A D D E N D U M N O . 1
H V A C - S L A D E

**HVAC IMPROVEMENT
PULASKI & SLADE MIDDLE SCHOOLS**

KBA #25014.00 KBA #25014.00 | SPN#089-173 HVAC-
PULASKI - SPN#089-174-SLADE

Date: March 6, 2026

**FIRST FLOOR
MECHANICAL PIPE
PLAN - AREA C**

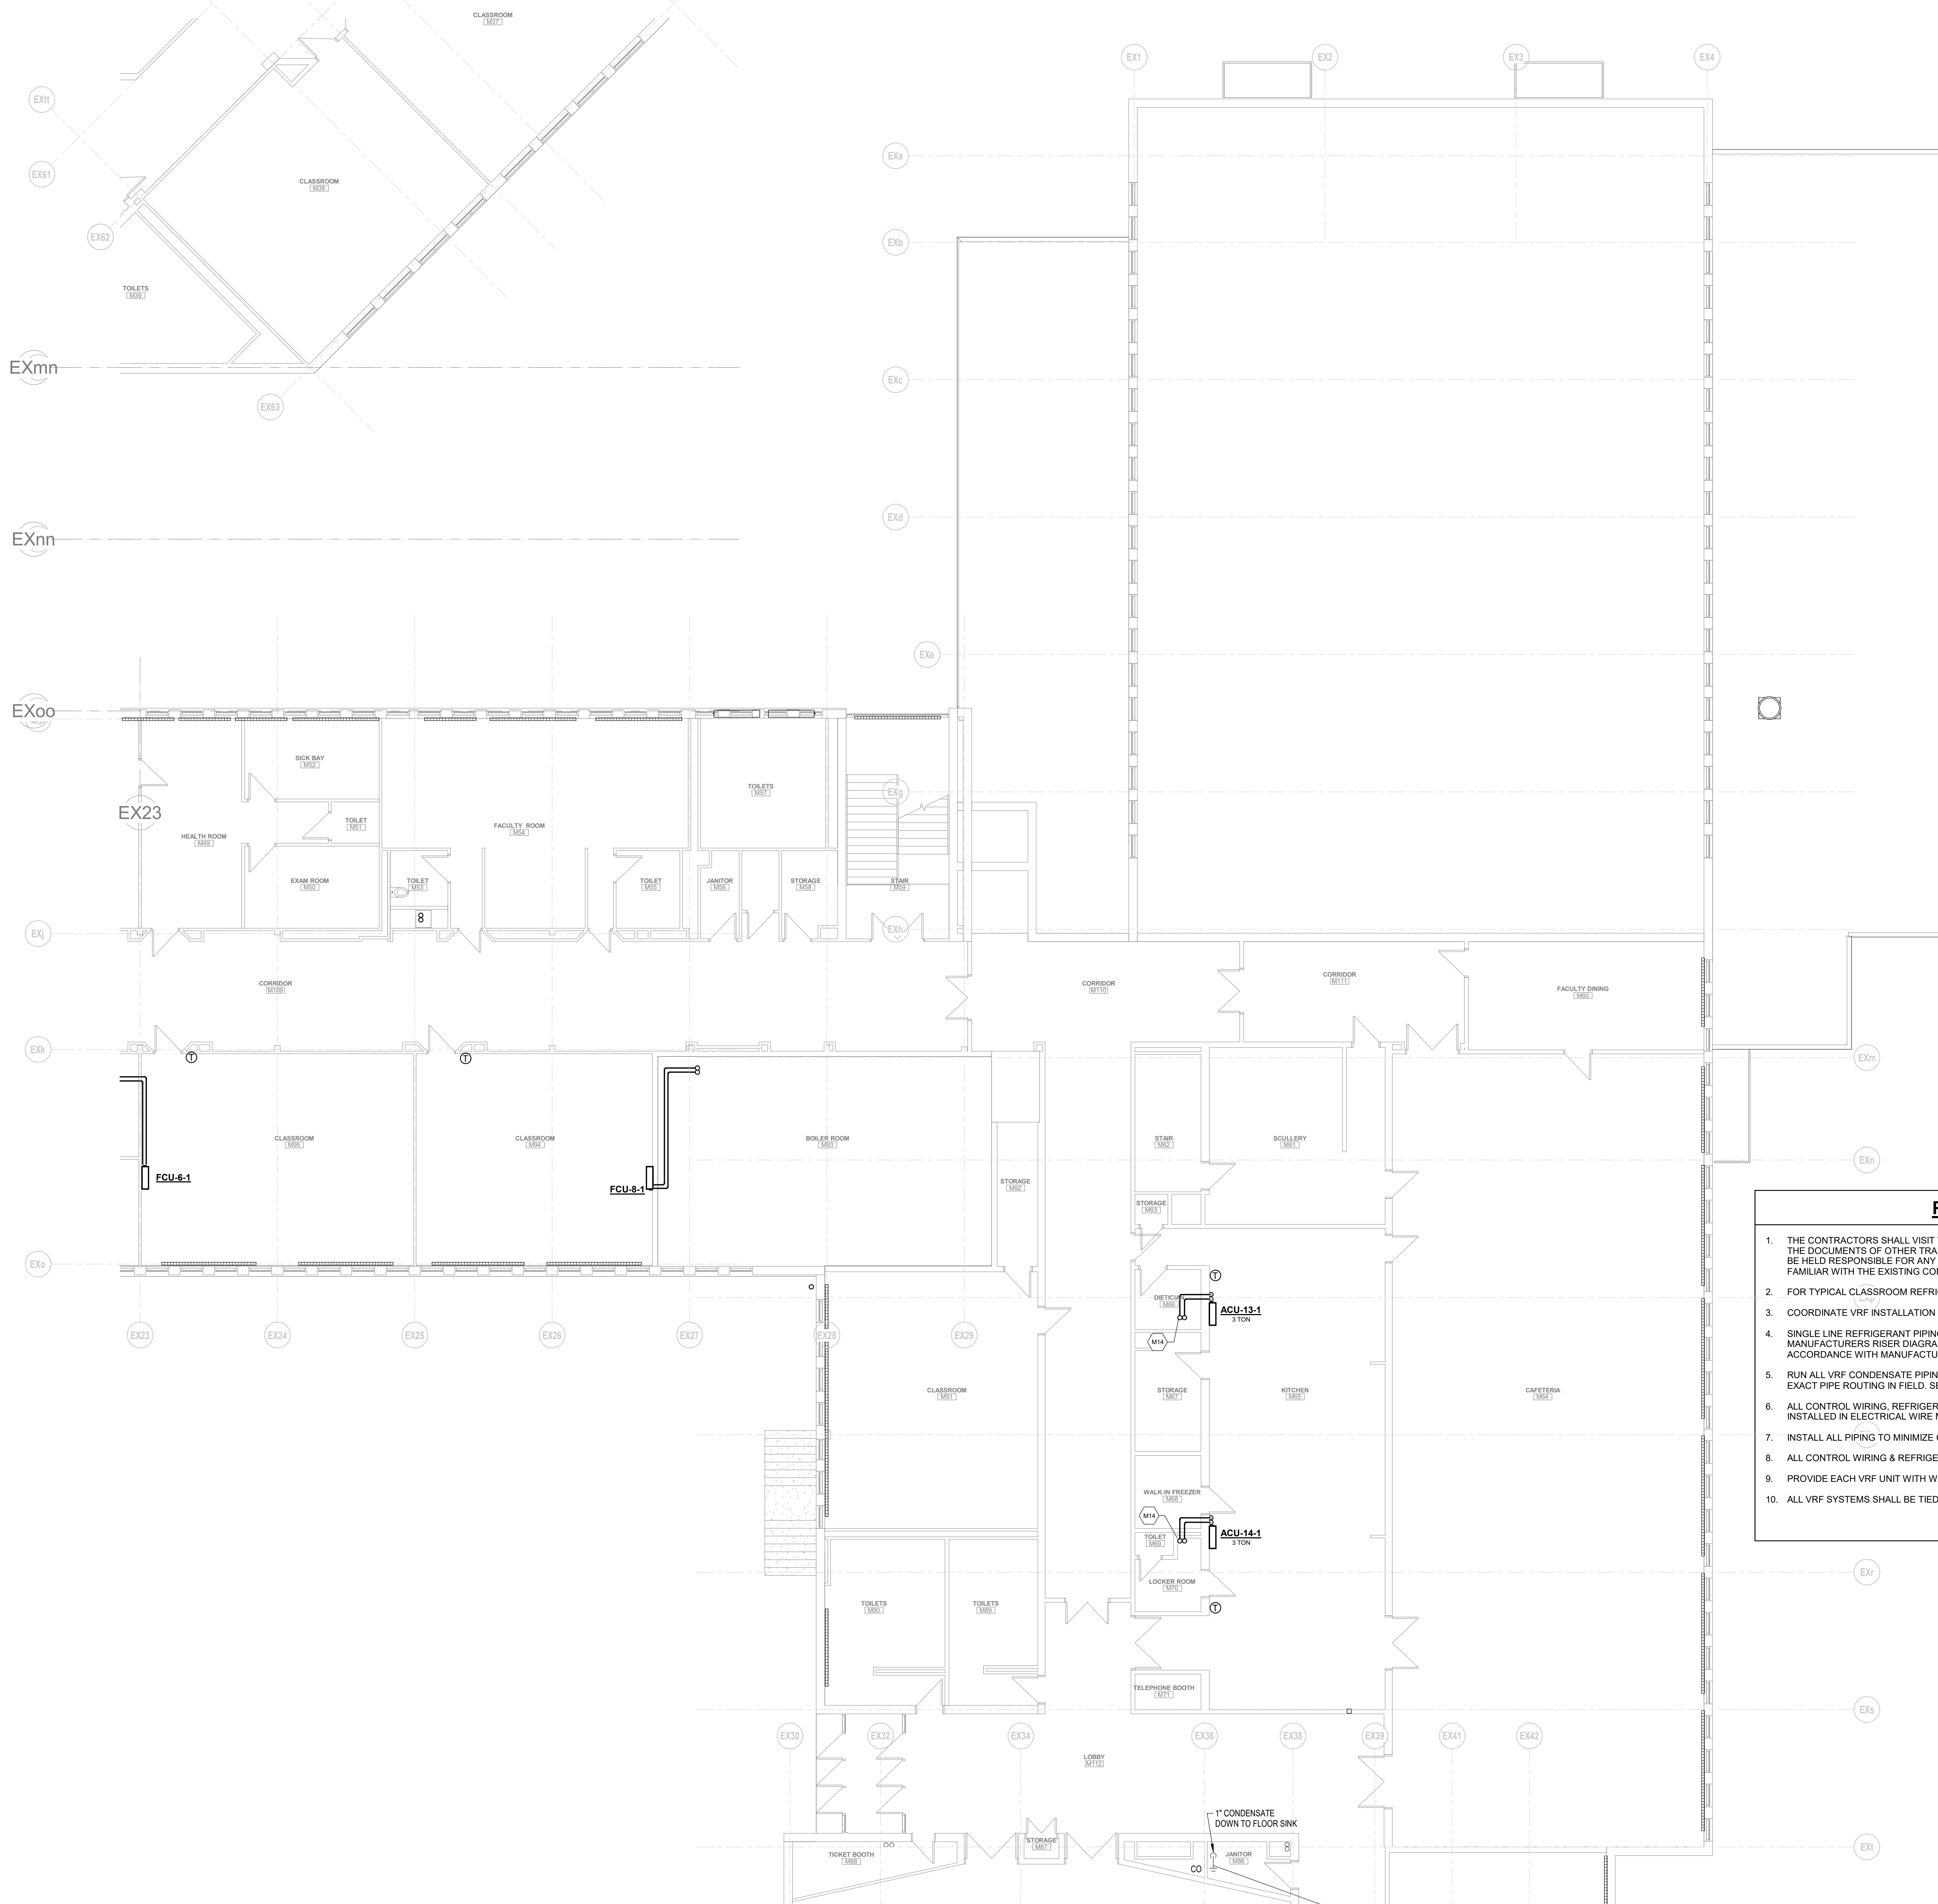
M2.01D FIRST FLOOR MECHANICAL PIPE PLAN - AREA D

Reissued to read:

M2.01C FIRST FLOOR MECHANICAL PIPE PLAN - AREA C
